**Public Submission**

**Jupiter Wind Farm EIS**

**Residence J234A / J234B**

Date: 5 February 2017

*Figure 62: Turbines based on distances of 2300m and 3450m from J234A*

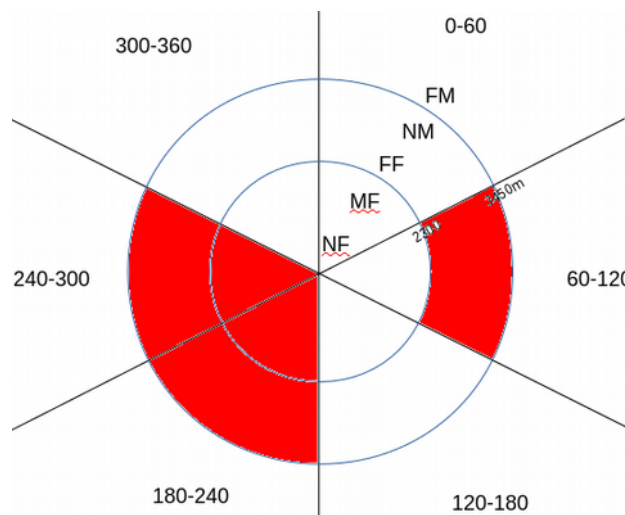
Figure 62 is based on the draft Framework. Based on a Level 2 Sensitivity (Moderate) for Rural Residences, and a Moderate scenic quality, within 2300m of J234A we have 5 WTGs. Within 3450m of J234A we have 21 WTGs. These distances were selected based on Table 8 of the draft framework based on the green and black lines.

Figure 70: Map of Sand Hills bushfire, January 2013

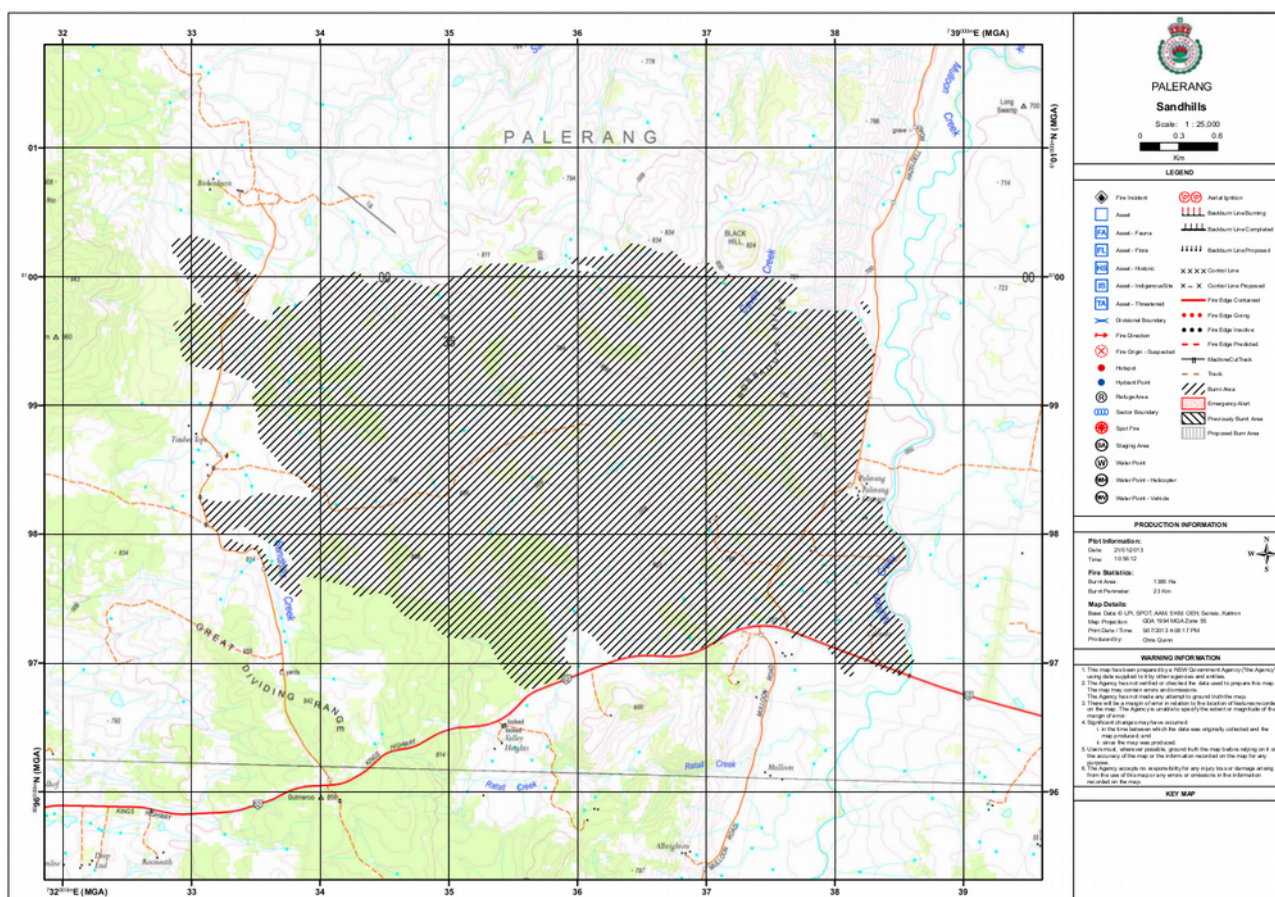
Upon request, the NSW RFS provided a map of this bushfire (Figure 70). No doubt additional information on the fire would also be on record if EPYC had requested it. In addition, EPYC and ERM do not appear to have approached local fire brigades to ask about local fire history. This local knowledge is critical to understanding the actual bushfire risks in the area.

**Recommendation 106:** EPYC and ERM must engage with local bushfire brigades to gain a better understanding of local bushfire conditions and reassess the bushfire risks.

Figure 80: Prevailing wind direction follows Lower Boro Road

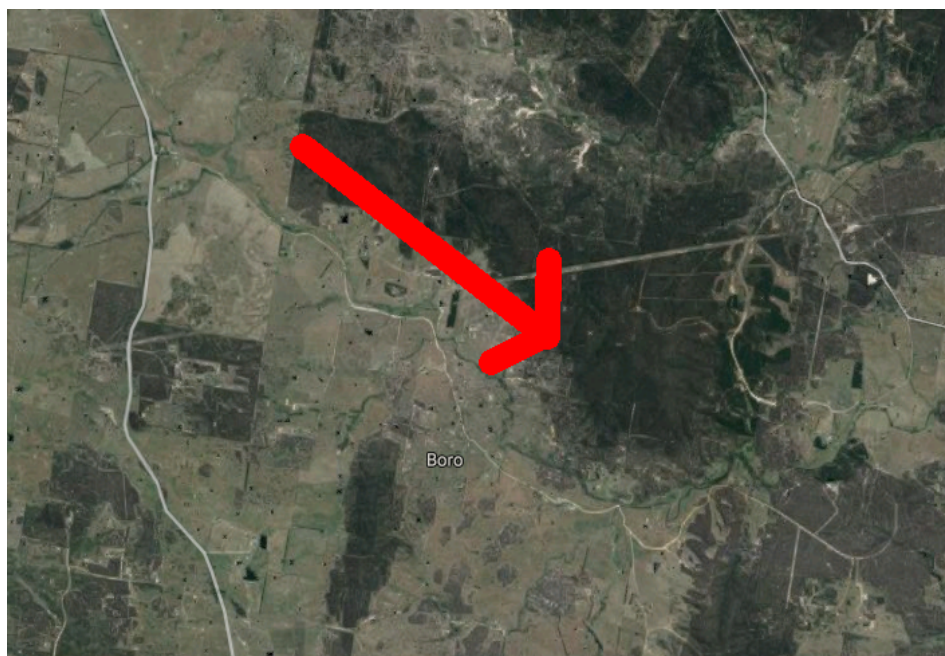
Of particular note in relation to the proposed Jupiter Wind Farm is the prevailing wind direction in relation to Lower Boro Road (in particular). Hotter and drier conditions typically persist with westerly and north-westerly winds, bringing hot air from central Australia. The most likely scenario for bushfires will be from a north west to south east direction.

This presents a particular problem for Lower Boro Road – access to fight the fires will always be from the rear of the fire. Even with additional tracks from the proposed Jupiter Wind Farm, access remains from the rear. This presents a problem to ground based resources. Thus it is important to have aerial firefighting appliances available for this area. These resources can assist in delaying (or stopping the fire in its tracks) until sufficient ground based resources can get in front of the fire.

**Rejection 113:** *The Jupiter Wind Farm proposal must be rejected. The 75 wind turbines in the northern precinct represent a significant risk when considered in relation to the prevailing winds and the orientation of Lower Boro Road along the north west to south east direction.*
